Registration Date:	25-Apr-2024	Application No:	P/08979/003
Officer:	Shivesh Seedhar	Ward:	Langley Foxborough
Applicant:	Elstree Land	Application Type:	Major
		13 Week Date:	25 July 2024
Agent:	Mr. Ben Thomas, Savills 33 Margaret Street, London, W1G 0JD		
Location:	Former Police Station, Trelawney Avenue, Langley, Slough, SL3 8NF		
Proposal:	Redevelopment of the site to provide 29 residential dwellings comprising self-contained flats and houses with associated car parking, access, landscaping, and other associated infrastructure.

Recommendation: Delegate to the Planning Group Manager for approval

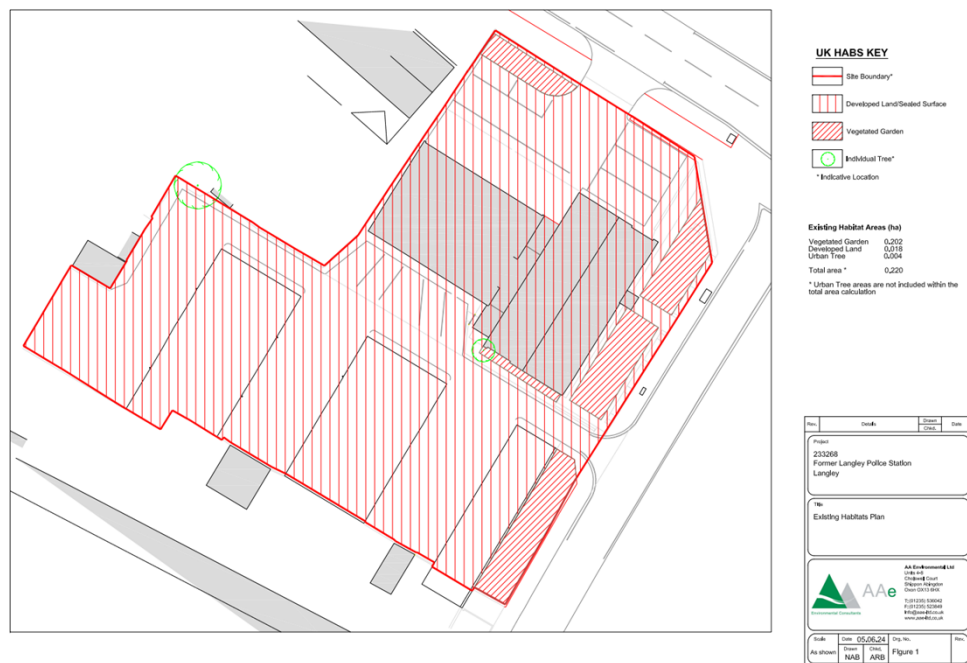
- the proposed gated access from Trelawney Avenue resulting in members of the public trying to access the front doors of the coach houses.
- the un-gated access via High preventing the rear car parking area, communal access to the flats from being effectively secured.
- the entrance to ground floor accessible flat being set back under the building canopy having no surveillance and the entrance being shared with site-wide services.

The CPDA has recommended that details in relation to the following should be provided:

- the operation of the proposed gate should be provided, and the installation of an additional gate via High Street to prevent unrestricted access through the development.
- Details for postal/delivery access.
- Details for the bin and cycle store access.
- An access and strategy document to demonstrate how potential for crime and anti-social behaviour has been considered/mitigated.

- 14.3 It is considered by Officers that the site would benefit from natural surveillance to all sides of the site, with windows and balconies overlooking the car parking areas, which will contribute to deterring criminal activity.
